# SERVICE BULLETIN

Classification: AT15-015b	Reference: NTB15-086b	Date: April 1, 2016
------------------------------	--------------------------	------------------------

## 2013-2015 ALTIMA AND 2014-2016 ROGUE; MIL ON WITH DTC P0776

This bulletin has been amended. Instructions have been changed and parts information added for installing a new oil strainer when the valve body is replaced, and Applied Vehicles updated. Please discard all previous versions of this bulletin.

Figure 18

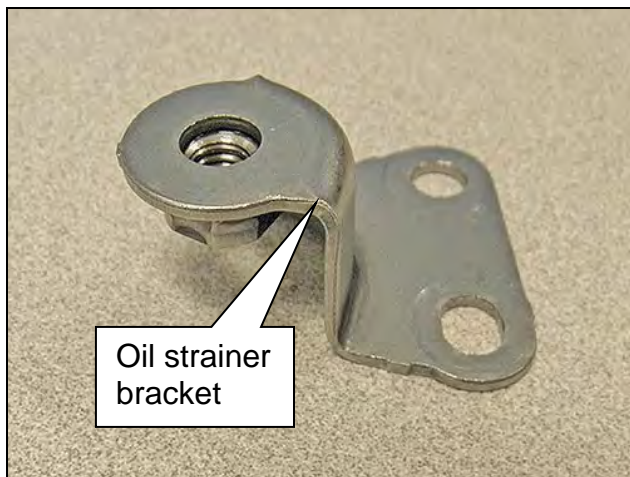
1. Discard the oil strainer bracket (Figure 18).
2. Install a new lip seal. Do NOT reuse the old lip seal (Figure 19).

Figure 20

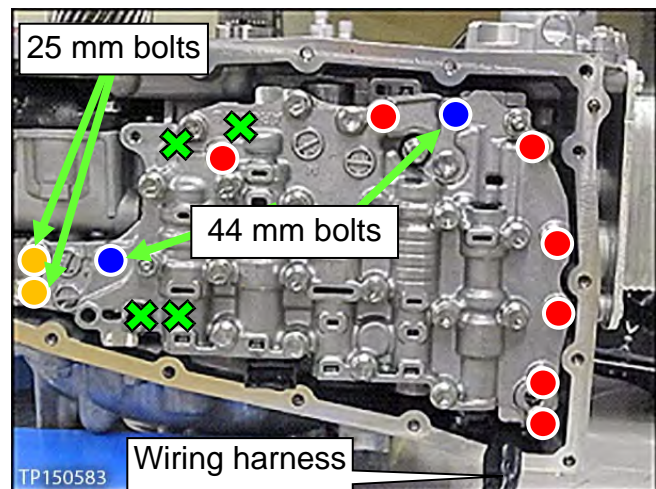
3. Install the Control Valve with nine (9) mounting bolts (Figure 20).

**IMPORTANT:** Leave Four (4)  bolt holes blank at this step.

- 54 mm long bolt  – 7 pieces
- 44 mm long bolt  – 2 piece
- 25 mm long bolt  – 2 piece

**CAUTION:** These two bolts are installed WITHOUT the strainer bracket.

Figure 21

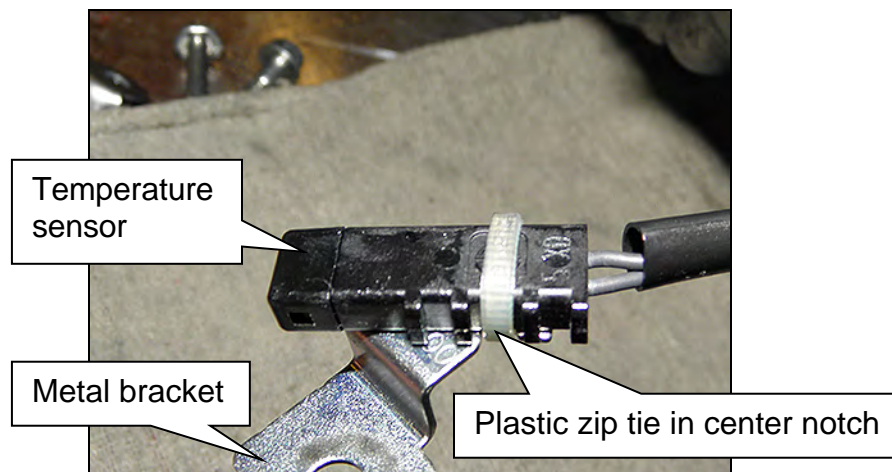
4. Replace the metal bracket of the temperature sensor as follows:

**NOTE:** The new bracket will be oriented the same way the old bracket was.

- a. Cut the plastic zip tie with an appropriate tool to remove the temperature sensor bracket from the terminal harness assembly. (Figure 21).

**CAUTION:** Cut the plastic zip tie over the metal bracket to avoid damage to the temperature sensor.

- b. Discard the removed bracket and plastic zip tie.
- c. Use the plastic zip tie from Parts Information to attach the new temperature sensor bracket to the temperature sensor of the terminal connector harness.

**IMPORTANT:** Locate the plastic zip tie at the **center notch** of three notches on the temperature sensor.

Figure 23

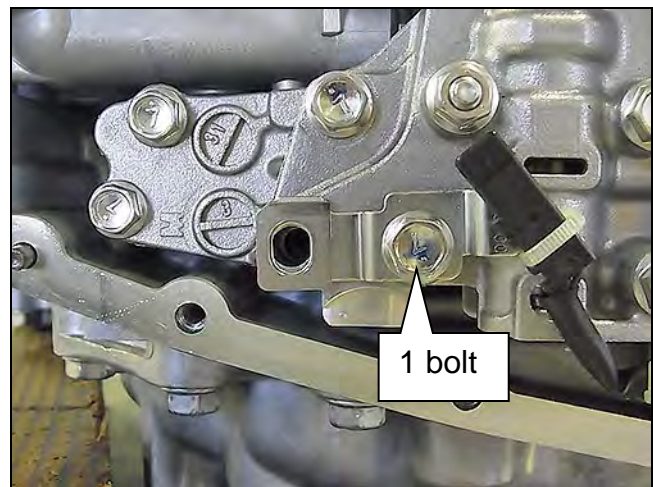
6. Install the CVT fluid temperature sensor bracket to the valve body with one (1) bolt (Figure 23).

**NOTE:** Leave one (1) bolt hole blank as it will be used to secure the oil strainer at a later step.

- Bolt torque: 8.0 N•m (0.81 kg-m, **70.8 in-lb.**)
- Bolt length: 54 mm

Figure 24

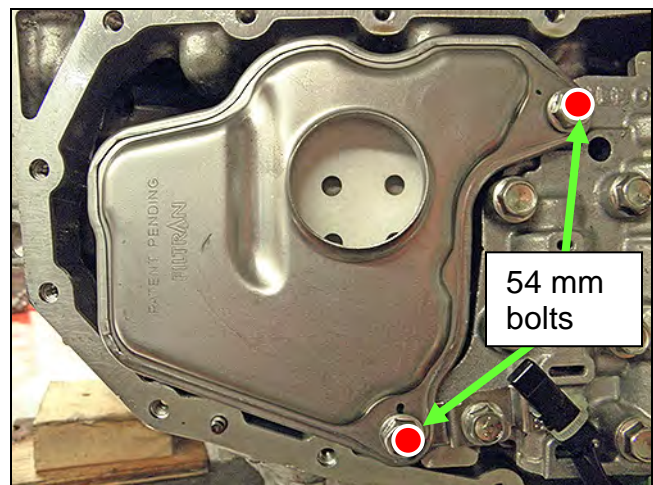
7. Install the new oil strainer with its new O-ring seal with two (2) bolts (Figure 24).

**NOTE:** replacement strainer maybe a different shape.

- Bolt torque: 8.0 N•m (0.81 kg-m, **70.8 in-lb.**)
- 54 mm long bolt  - 2 pieces.
